FLIGHT CONTROL SYSTEM CRITERIA FOR ADVANCED AIRCRAFT FOR INCORPORATION INTO AN UPDATED MILITARY SPECIFICATION

H. GLICKMAN GRUMMAN AEROSPACE CORPORATION BETHPAGE, NEW YORK 11714

JUNE 1980

FIGURE 2 BRAKE PEDAL TRAVEL

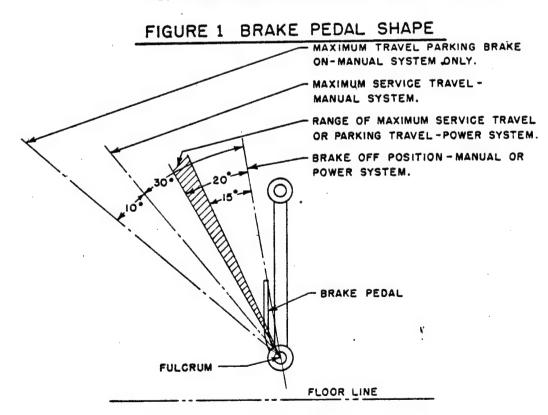
- d. The travel of the pedal shall be as indicated in Figure 2. It shall be between 15 and 20° to meet the requirements of subparagraph b above.
- 3.2.2.3 Emergency Brake Control The location and actuation of the emergency brake control shall be as indicated in MIL-5TD-203.
